SITE PLAN APPLICATIONDate 2-22-88NAME OF PROPOSED DEVELOPMENT Buffalo Creek Shopping Village No 2NAME OF PROPERTY OWNER/DEVELOPER Buffalo Creek Development CorpADDRESS Box 369, Rockwall, TX PHONE 771-5238NAME OF LAND PLANNER/ENGINEER Chuck Hodges, Harold EvansADDRESS Bridge Rd, Rockwall TX PHONE 771-0044TOTAL ACREAGE 2 acres CURRENT ZONING P.D.NUMBER OF LOTS/UNITS 1SIGNED [Signature]

Case No. 88-13 CUP

RETAIL NURSERY SITE PLAN

Notes on Whittle Garden Center

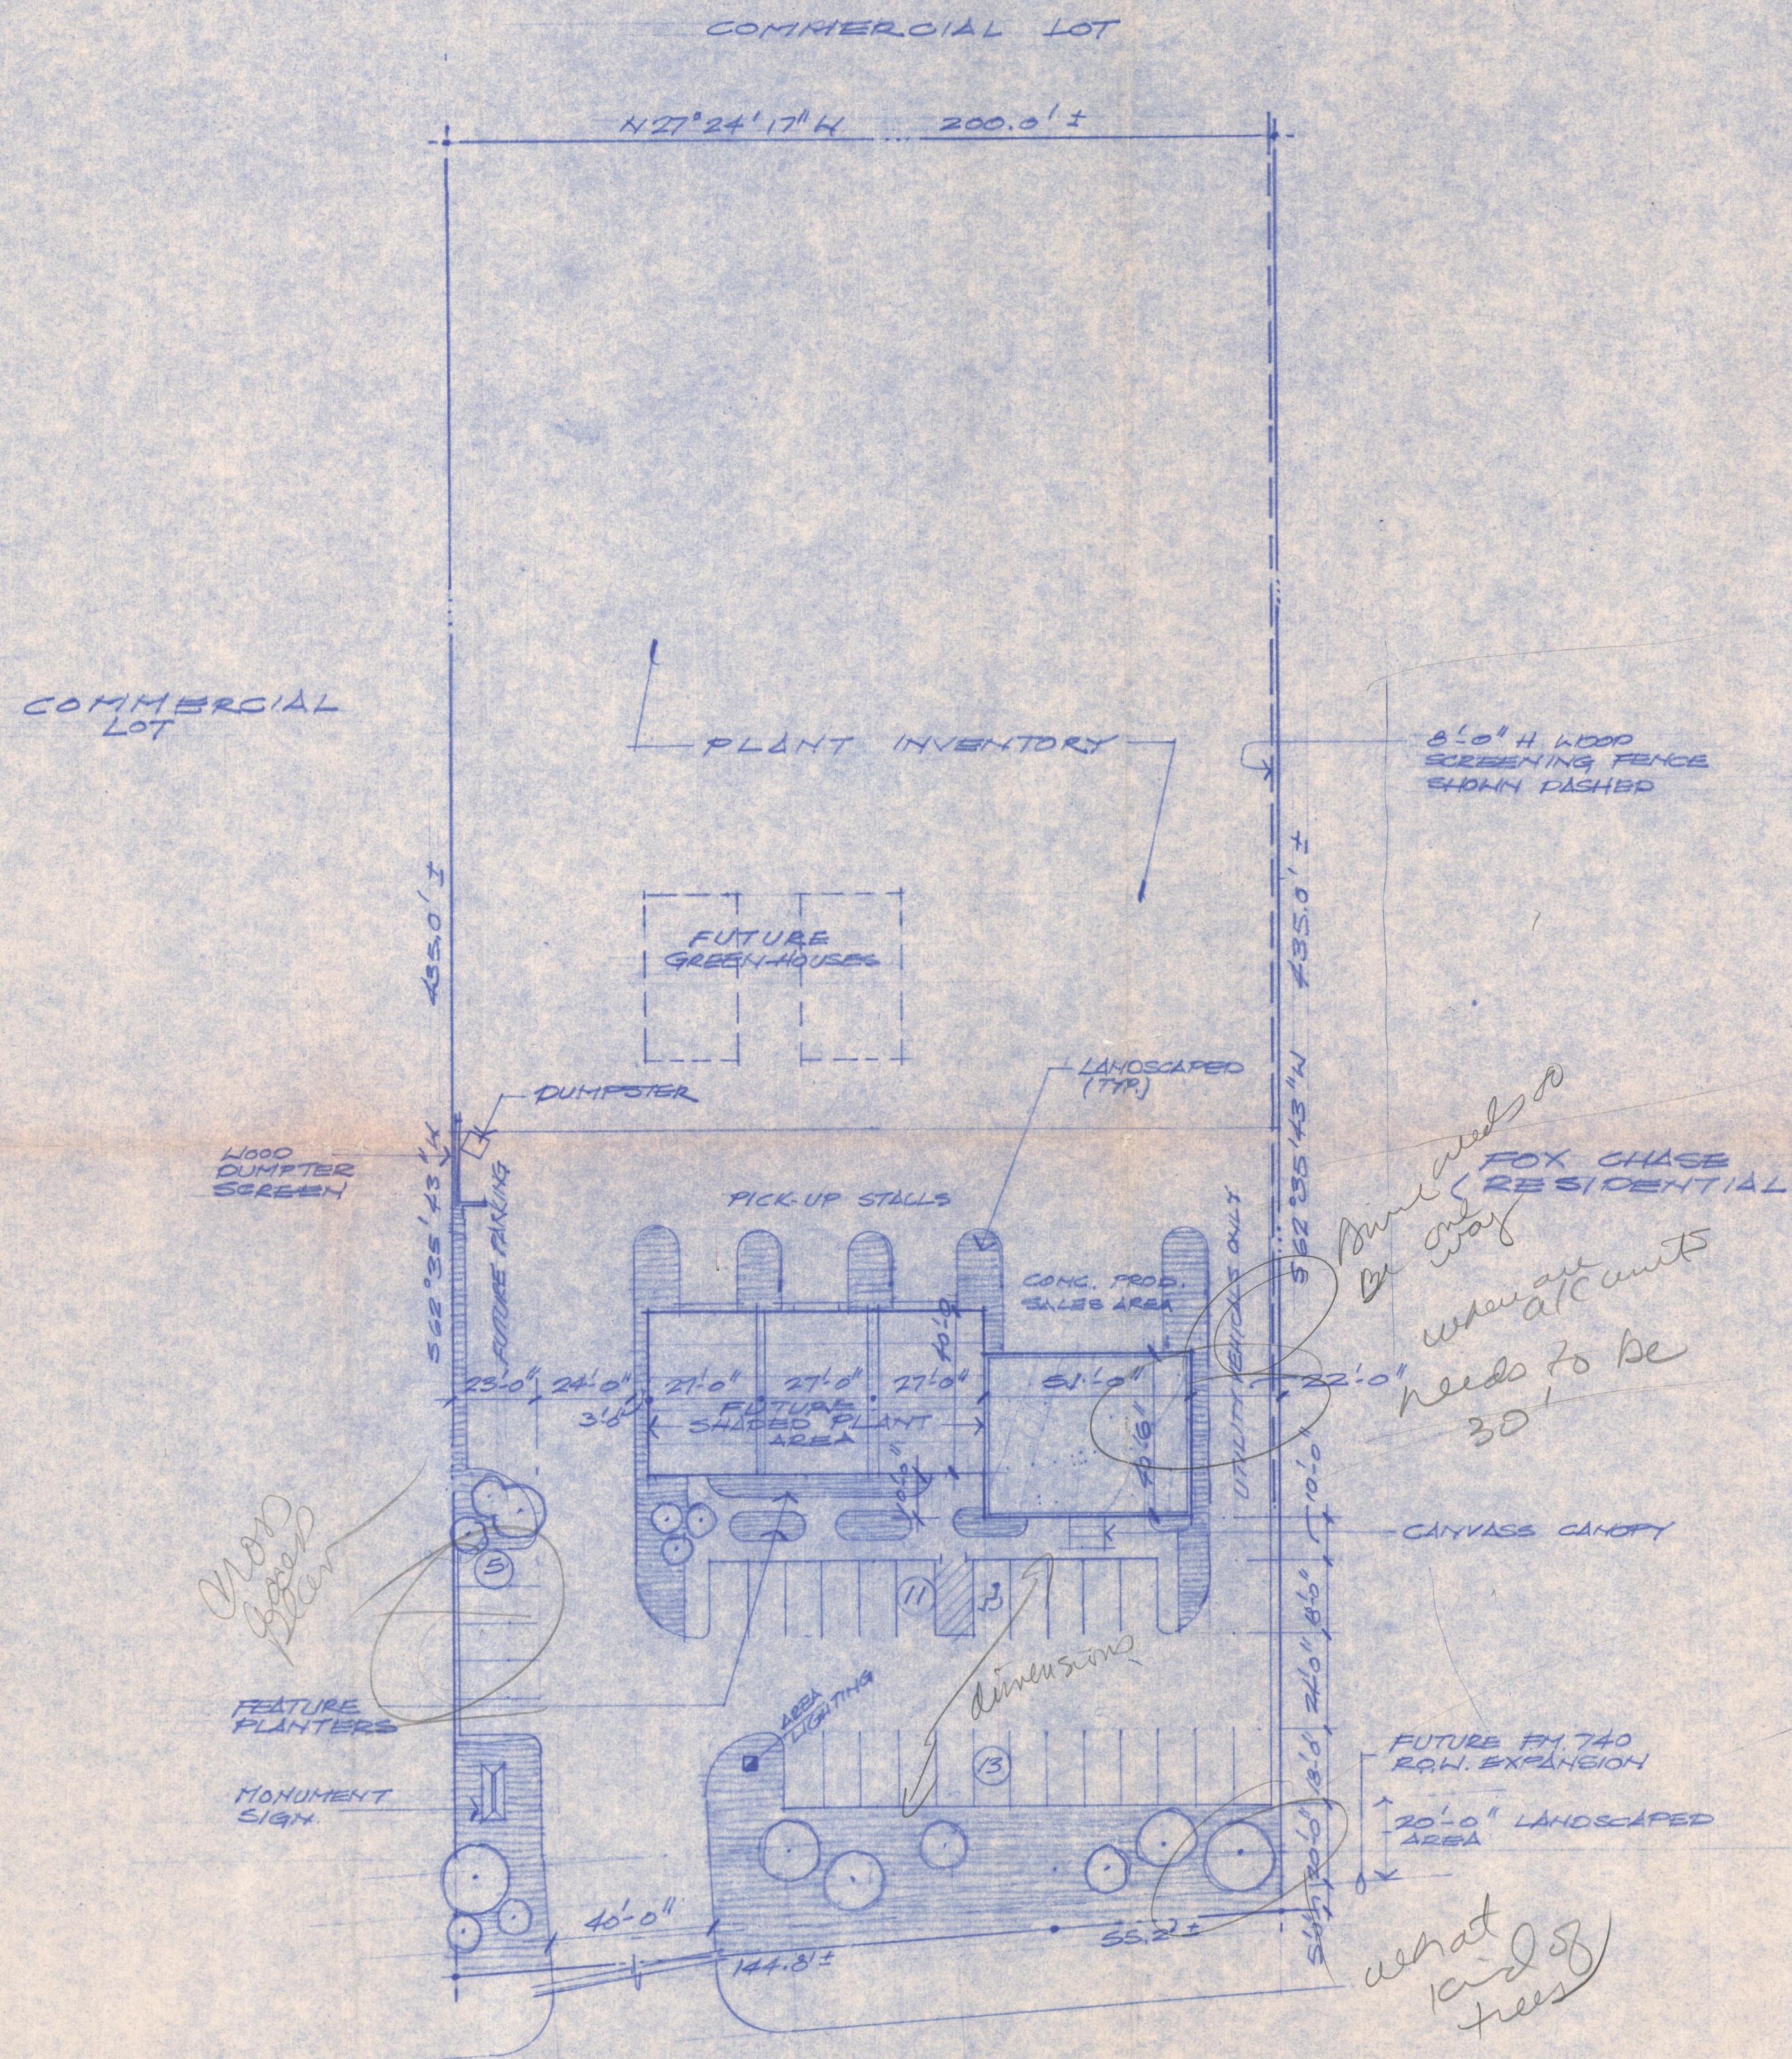
1. One major concern, as with the other sites in PD-9, was the lack of a Concept Plan for the entire area. We requested the developer to provide a Concept Plan and he has done so. A copy of the Concept Plan is included in the packet.
2. Cross access easements need to be provided for connection with sites to the north.
3. All other technical concerns were addressed by the developer at the time P&Z reviewed the application.

1. One major concern, as with the other sites in PD-9, is that we don't have a Concept Plan for the entire area. We have requested the developer to provide a Concept Plan.
2. Cross access easements need to be provided for connection with sites to the north.
3. The building needs to be set back off of the side property line 30 feet, adjacent to the residential.
4. A timetable for completion of Phase 2 may be an item to discuss.
5. The dumpster screen needs to be of the same material as the main structure.
6. Under the Overlay District, the screening fence must be of masonry unless otherwise approved by P&Z and Council.
7. The brick used on this facility needs to blend with the brick used on Mr. M.

1. need concept plan
2. need reductions
3. need legal desc.
4. How does this tie into 1997 & Phase I
5. Don't need 10' dedication - check w/ John
6. need more site plans, elevations, ~~also~~ no legal description
7. Fena needs to mention entire layout of pipeline, wood?
8. What type of landscaping
9. what is going on future - what will be done until then
10. need dimensions on parking area
11. what will the sign look like
12. Wood dumpster screen?
13. set back not correct
14. where are up units - needs to be secured
15. cross access easement
16. what color brick - what color stucco? pool - masonry?

18. Need to look at dumpster access

19. Drive needs to be under or
one way

1. A Concept Plan of the entire area is needed to understand the relationship of this proposal to the entire tract.
2. Cross access easements should be provided on all sites along FM-740 to allow through access to Summer Lea when that is developed.
3. A determination needs to be made on whether the screening wall should be extended to the property line along the wall.
4. The screen around the dumpster needs to be masonry to match the building.
5. The side setback along the property line adjacent to the residential development to the south needs to be increased.
6. The a/c units need to be identified and screened.

4. A site plan subject to the following conditions:
 - a. the building is a permanent structure
 - b. screening is masonry, not wood
 - c. front and sides are all brick

- h. any vehicle left on the site will be located behind the building in the area designated as concrete products sales area
 - i. cross access drive needs to be shown on the site plan

The Rockwall City Council will hold a public hearing on April 4, 1988, at 7:00 P.M. in City Hall, 205 West Rusk and consider approval of your request. Please provide seven additional copies of the site plan showing location of cross access drive,

Please submit four copies of a revised site plan indicating cross access easements to the north where parking is currently shown. These must be submitted for our permanent files prior to issuance of a building permit. Please call if you have any questions.

BUFFALO CREEK SHOPPING VILLAGE NO. 2	
E. TEAL SURVEY-ABSTRACT NO. 207	
CITY OF ROCKWALL, ROCKWALL COUNTY, TEXAS	
WHITTLE DEVELOPMENT, INC. ~ OWNER	
2804 RIDGE ROAD, ROCKWALL, TEXAS 75087 TEL. 771-8228

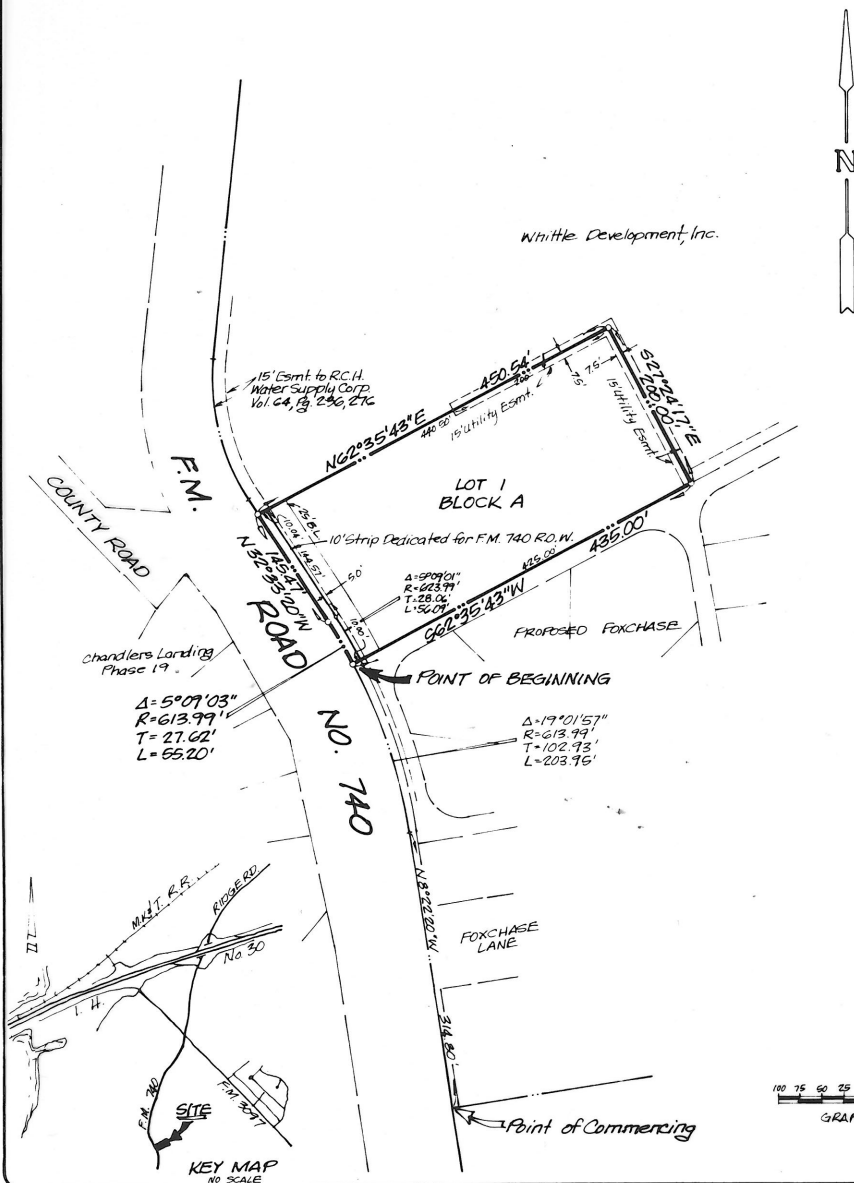
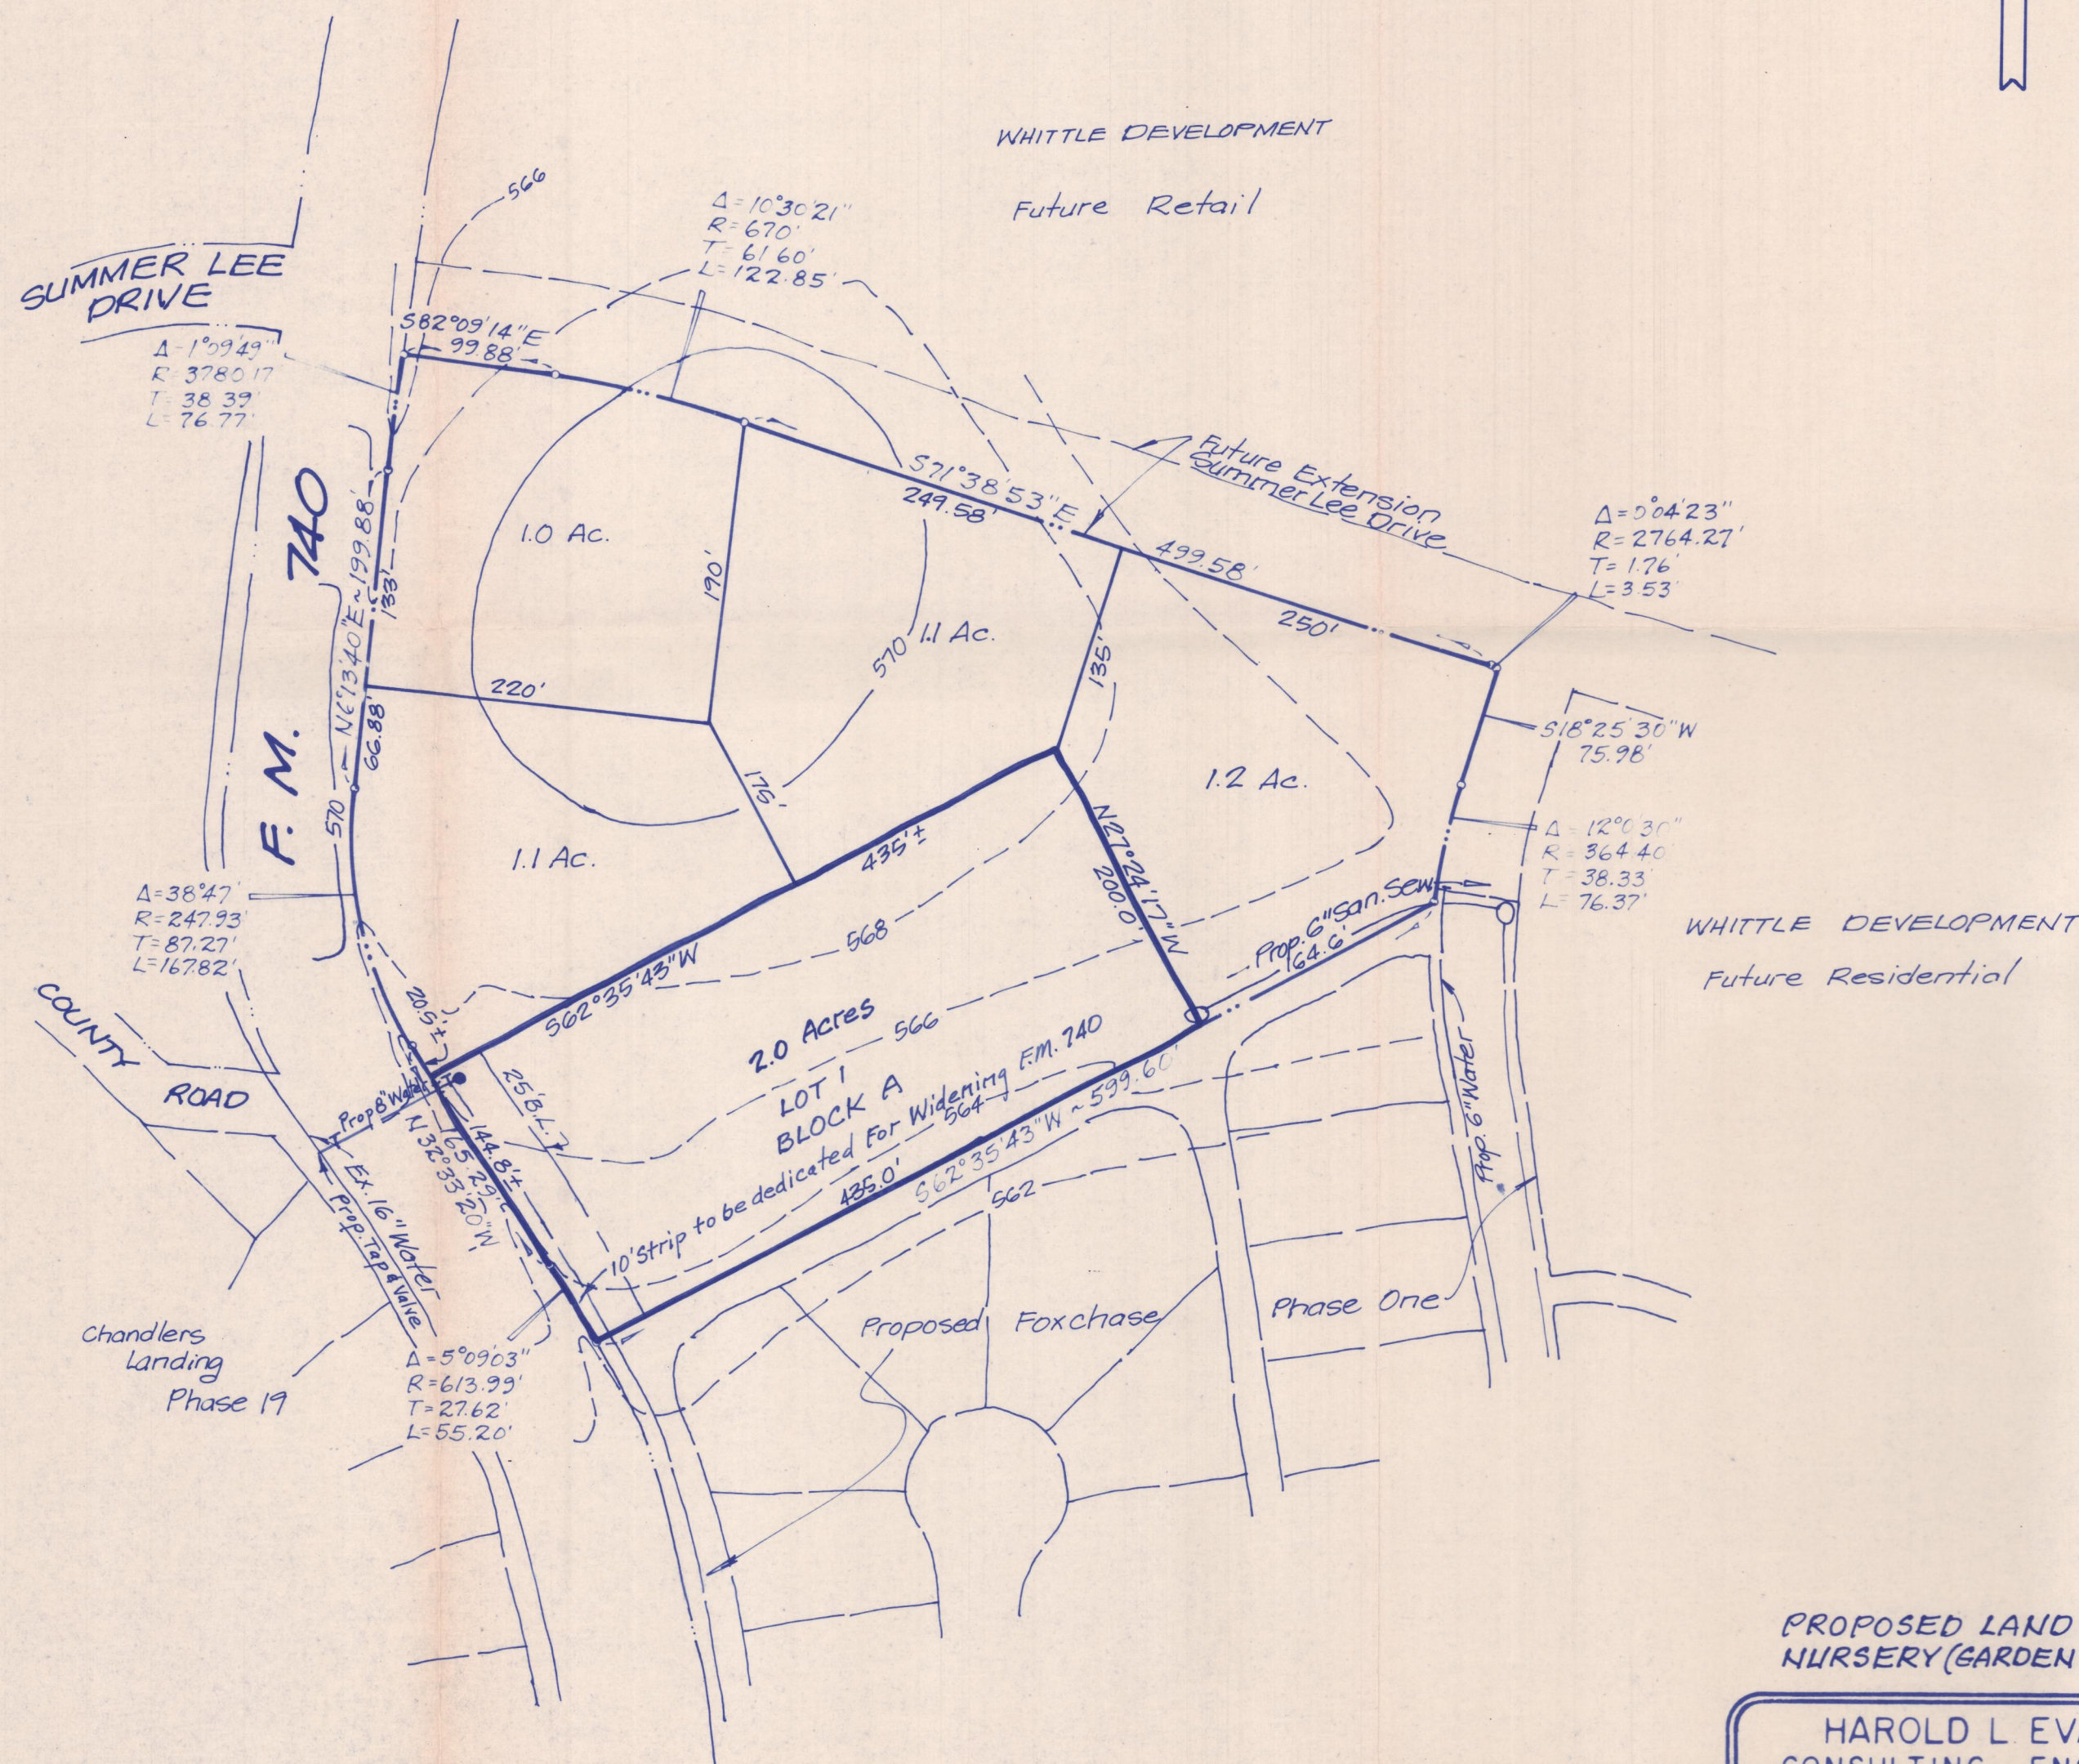
1. A determination needs to be made by the time of final plat as to what right-of-way might be needed to address the problem of the curve that exists on FM-740.

1. A determination needs to be made as to what right-of-way might be needed to address the problem of the curve that exists on FM-740.

3. a preliminary plat subject to:
 - a. provision of access easements for cross access to the north;
 - b. additional right-of-way dedication at the final plat stage to provide room for realignment of FM-740;
